<b>To:</b>	ATA Architects Inc. 211 Lakeshore Road East Oakville, Ontario L6J 1H7	<b>No.:</b>	<b>ADD-M03</b>
<b>Fax/Email:</b>	mark@ataarchitectsinc.com	<b>Date:</b>	November 4, 2024
<b>Attention:</b>	Mark Driedger	<b>Project:</b>	Fire Hall 7-1 835 Clark Ave. W., Vaughan, ON
<b>From:</b>	Cassandra Kani-Sanchez	<b>Project No.:</b>	<b>2021-0158</b>

This Addendum shall be attached to the drawings and specifications and shall form an integral part of the Contract Documents. The contents of this Addendum shall be brought to the attention of all concerned.

**M101**

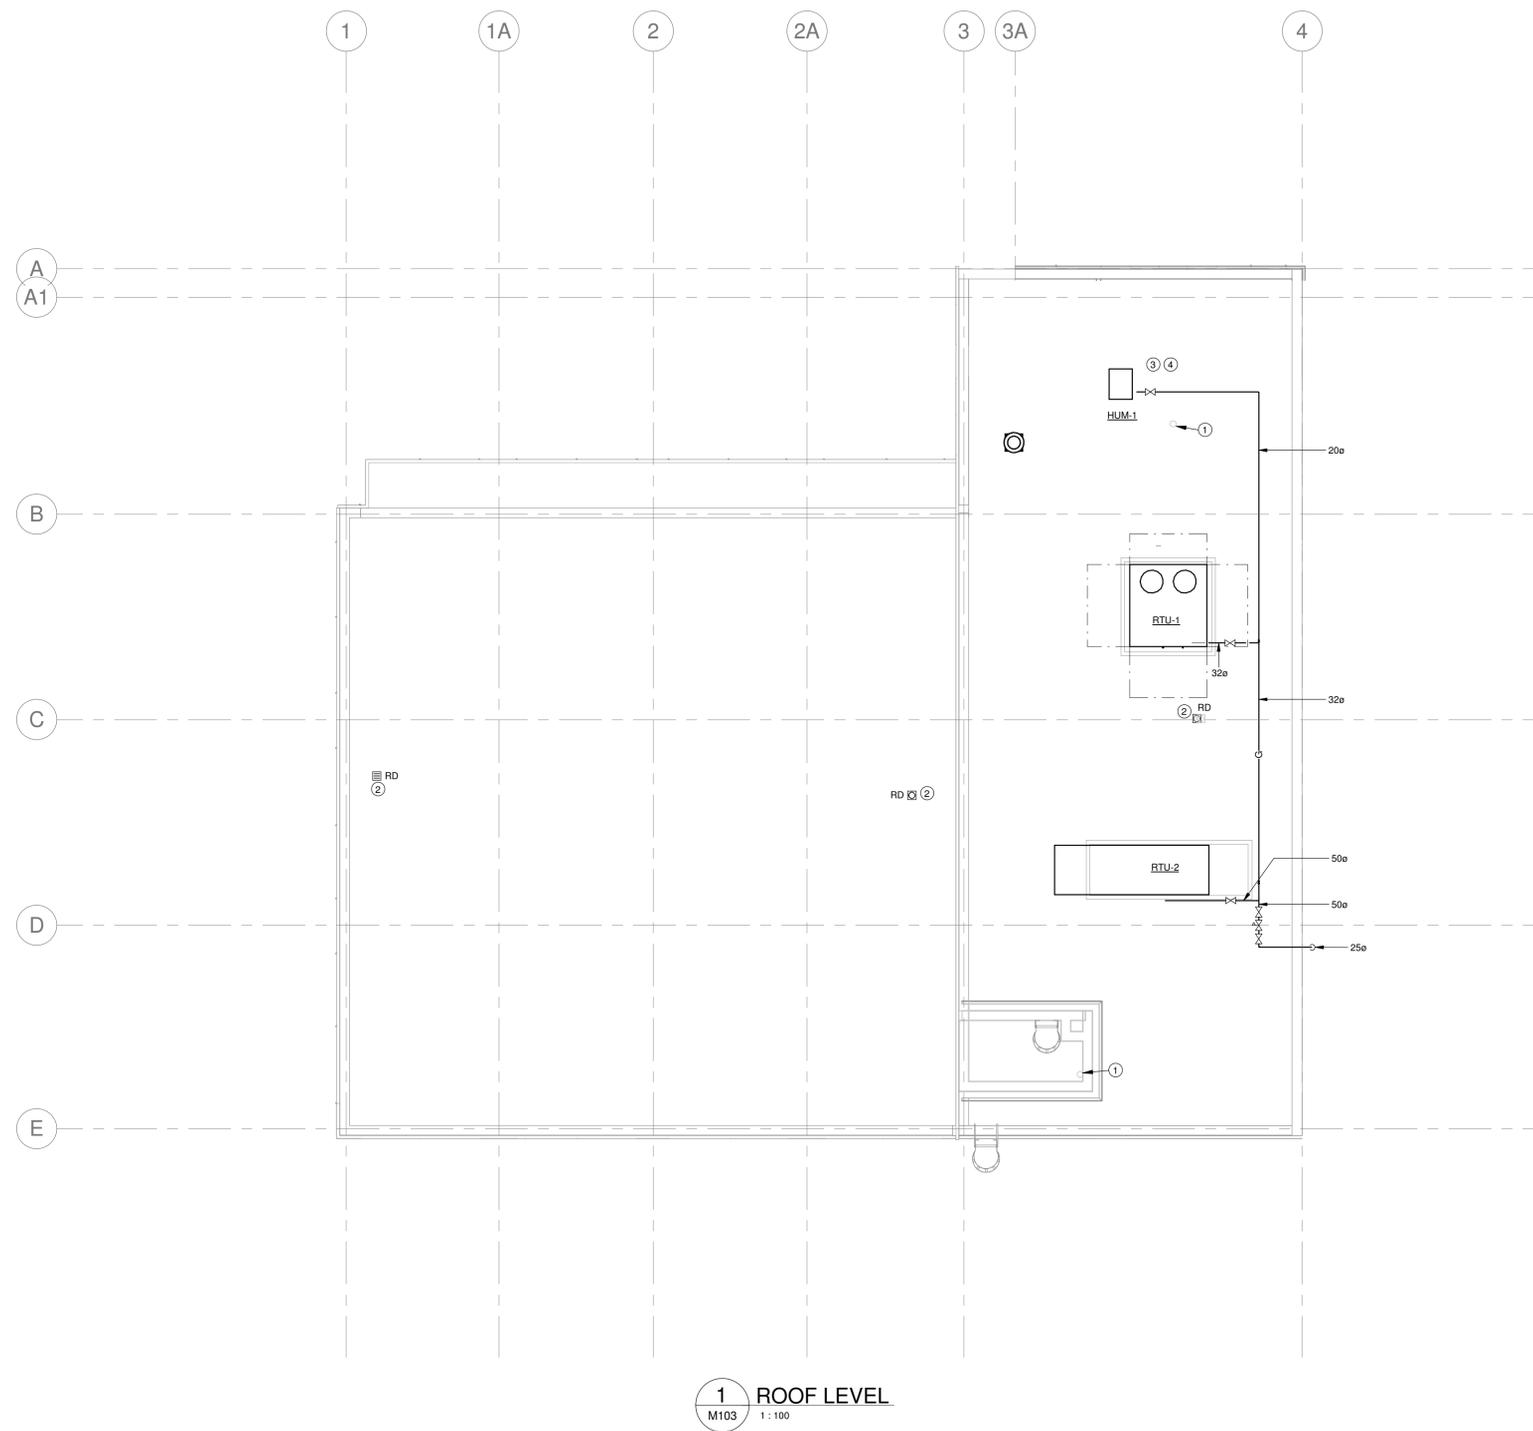
2.5. Drawing M101 – Ground Floor Plumbing & Drainage (drawing re-issued)

2.5.1. Drawing Note 3, revised, in its entirety, to read “Existing storm drain to remain. Remove and replace existing roof drains; connect to existing maintained storm drain piping below roof. Note that this Scope of Work is excluded from the Base Bid Price, to be paid by Cash Allowance under Section 01 21 00 Allowances.”

2.5.2. Drawing Note 13, deleted, in their entirety, the final three sentences of this Note and substitute with “Additional costs incurred from Gas Utility for upgrades will be covered by Cash Allowance under Section 01 21 00.”.

- EXISTING STORM DRAIN TO REMAIN. REMOVE AND REPLACE EXISTING ROOF DRAINS; CONNECT TO EXISTING MAINTAINED STORM DRAIN PIPING BELOW ROOF. NOTE THAT THIS SCOPE OF WORK IS EXCLUDED FROM THE BASE BID PRICE. TO BE PAID BY CASH ALLOWANCE UNDER SECTION 01 21 00 ALLOWANCES. (TYPICAL)

- REMOVE AND REPLACE EXISTING GAS METER AND PRV. CONTRACTOR TO COORDINATE WITH GAS UTILITY. ADDITIONAL COSTS INCURRED FROM GAS UTILITY FOR UPGRADES WILL BE COVERED BY CASH ALLOWANCE UNDER SECTION 01 21 00. NEW 120Ø 2250 CONCRETE PAD TO BE POURED PRIOR TO INSTALLATION OF NEW GAS SERVICE STATION. (EXACT DIMENSIONS TO BE CONFIRMED WITH ENBRIDGE)

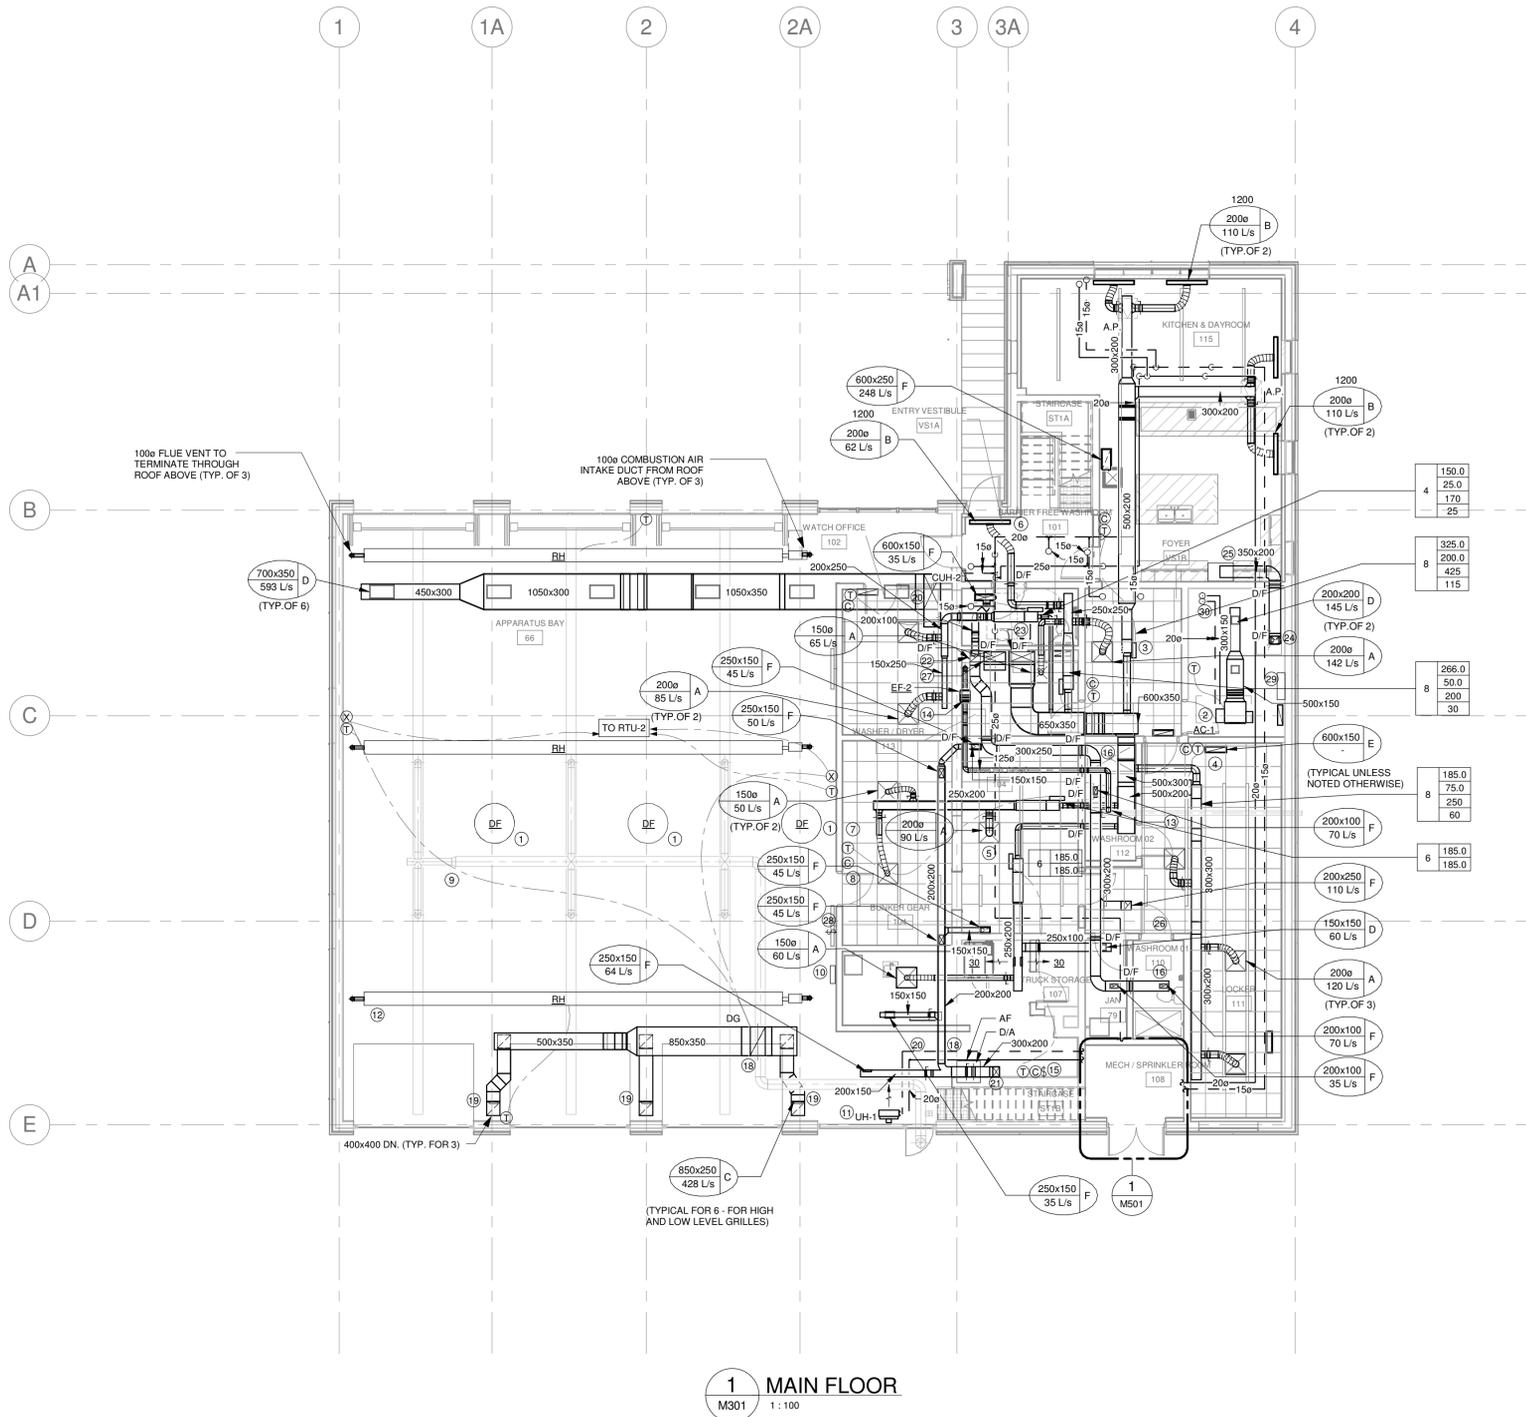
2.6. Drawing M102 – Second Floor Plumbing & Drainage (drawing re-issued)

2.6.1. Drawing Note 11, revised, in its entirety, to read “Existing storm drain to remain. Remove and replace existing roof drains; connect to existing maintained storm drain piping below roof. Note that this Scope of Work is excluded from the Base Bid Price, to be paid by Cash Allowance under Section 01 21 00 Allowances.”

2.6.2. Drawing Note 12, revised, in its entirety, to read “Remove and replace existing roof drains as required to facilitate roof waterproofing scope by others. Connect to existing storm drain piping below roof. Note that this

Scope of Work is excluded from the Base Bid Price, to be paid by Cash Allowance under Section 01 21 00 Allowances.”

- DRAWING NOTES:
- EXISTING VENT PIPE FROM BELOW TO REMAIN (TYPICAL)
  - REMOVE AND REPLACE EXISTING ROOF DRAINS AS REQUIRED TO FACILITATE ROOF WATERPROOFING SCOPE BY OTHERS. CONNECT TO EXISTING STORM DRAIN PIPE BELOW ROOF. NOTE THAT THIS SCOPE OF WORK IS EXCLUDED FROM THE BASE BID PRICE, TO BE PAID BY CASH ALLOWANCE UNDER SECTION 01 21 00 ALLOWANCES. (TYPICAL)
  - PROVIDE 150 DOW TO HUMIDIFIER FROM BELOW WITHIN HUMIDIFIER CABINET
  - PROVIDE 200 CONDENSATE AND 250 HUMIDIFIER DRAIN FROM HUMIDIFIER TO BELOW WITHIN HUMIDIFIER CABINET. TO BE ROUTED TO HUB-DRAIN SUSPENDED ABOVE CEILING BELOW.

PROJECT	
FIRE STATION 7-1 FACILITY RENEWAL	
835 CLARK AVENUE WEST THORNHILL, ONTARIO	
DRAWING	
GROUND FLOOR HVAC	
DRAWN	
CAD	
SCALE	
1 : 100	
DATE	
JULY 2022	
CHECKED	
CKS	
PROJECT	
2021-01-58	
DRAWING	
M301

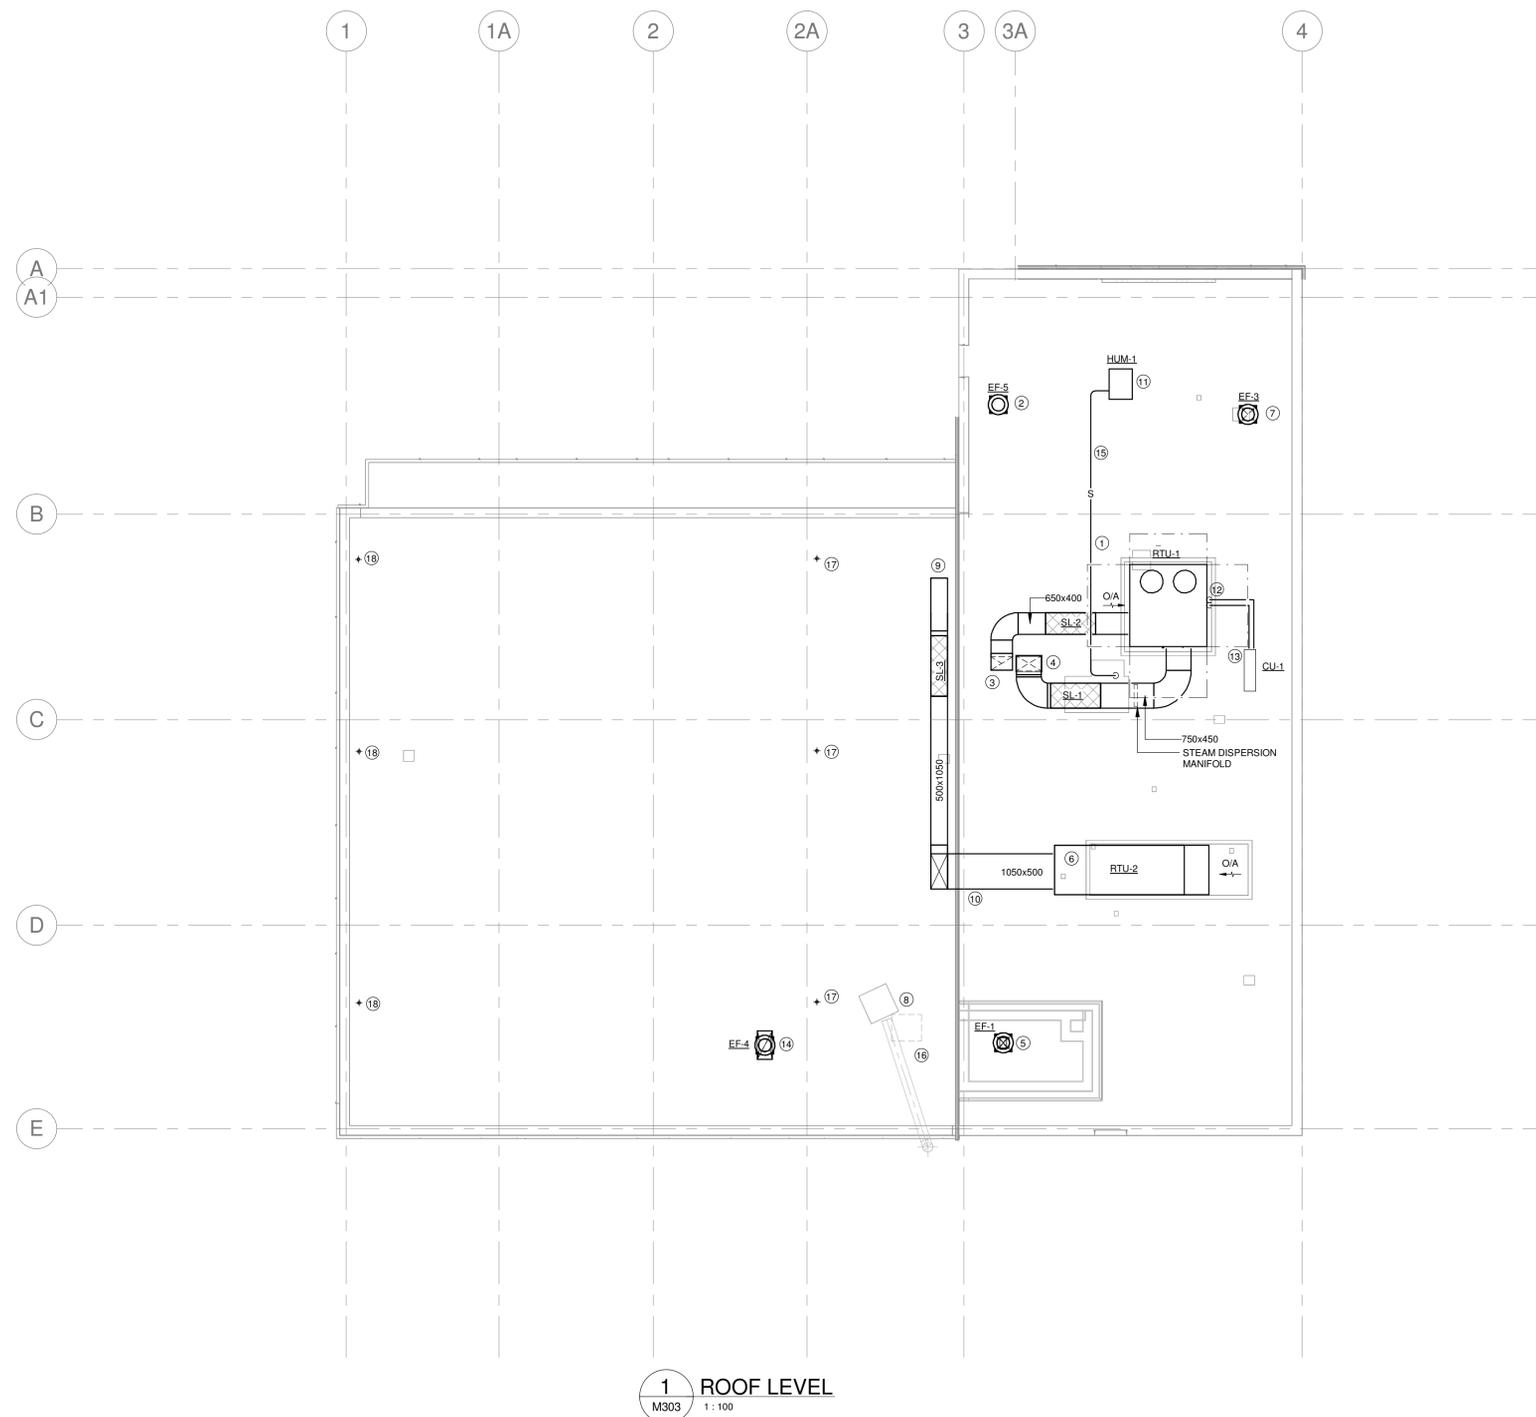
2.8. Drawing M301 – Ground Floor HVAC (drawing re-issued)

2.8.1. Drawing Note 9, deleted, in their entirety, the final three sentences of this Note and substitute with “Note that this Scope of Work is excluded from the Base Bid Price, to be paid by Cash Allowance under Section 01 21 00 Allowances.”

PROJECT	ROOF HVAC
<b>FIRE STATION 7-1 FACILITY RENEWAL</b>	
<b>835 CLARK AVENUE WEST THORNHILL, ONTARIO</b>	
<b>DRAWING</b>	
<b>DRAWN</b>	CAD
<b>SCALE</b>	1 : 100
<b>DATE</b>	JULY 2022
<b>CHECKED</b>	CKS
<b>PROJECT</b>	2021-01-58
<b>DRAWING</b>

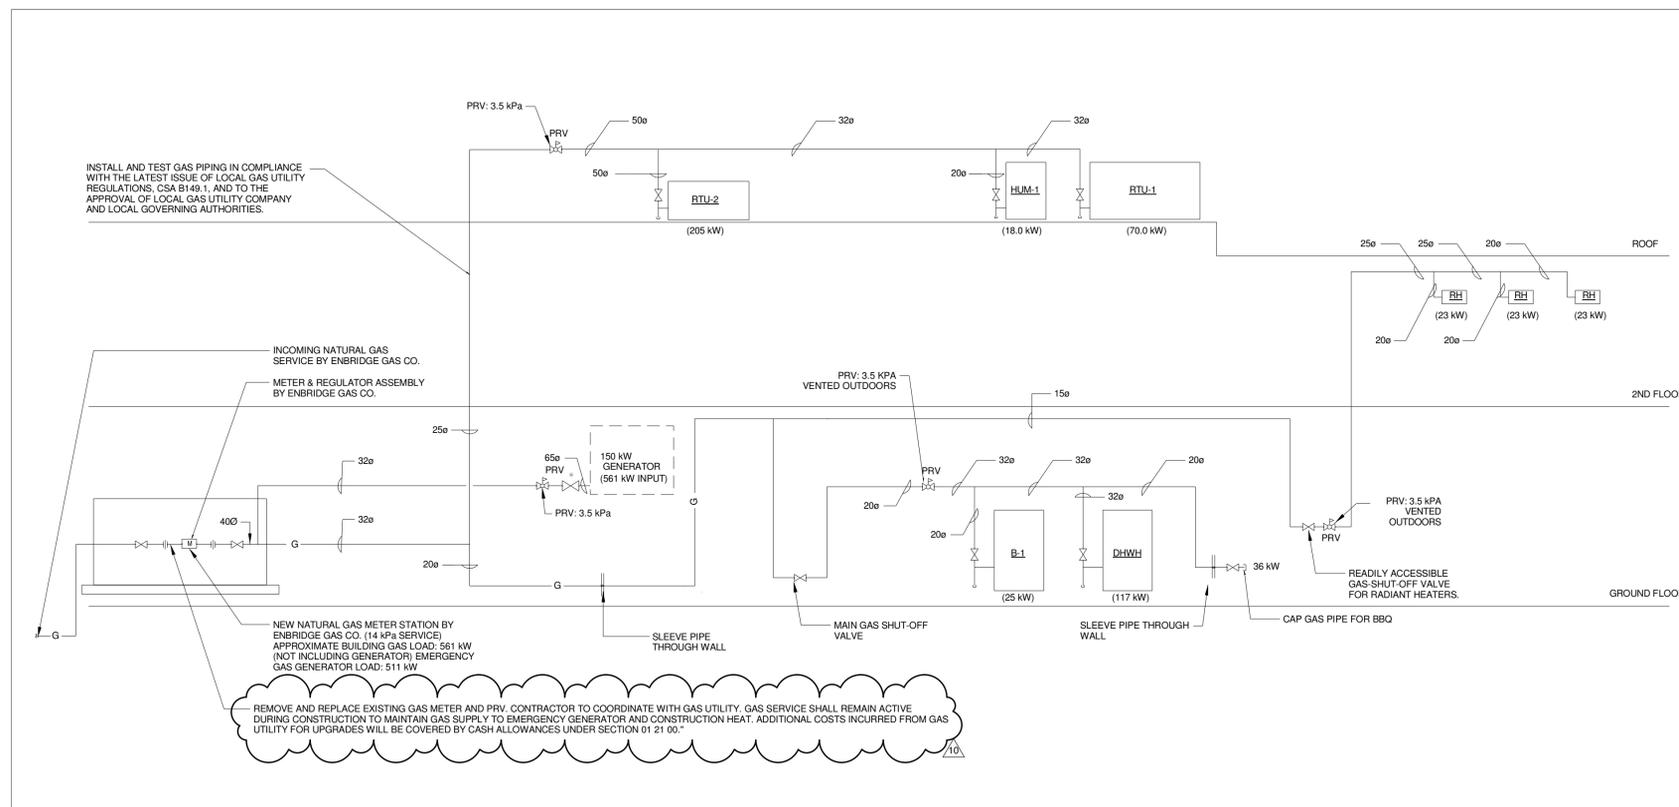
2.9. Drawing M303 – Roof HVAC (drawing re-issued)

2.9.1. Drawing Note 16, deleted, in their entirety, the final three sentences of this Note and substitute with “Note that this Scope of Work is excluded from the Base Bid Price, to be paid by Cash Allowance under Section 01 21 00 Allowances.”
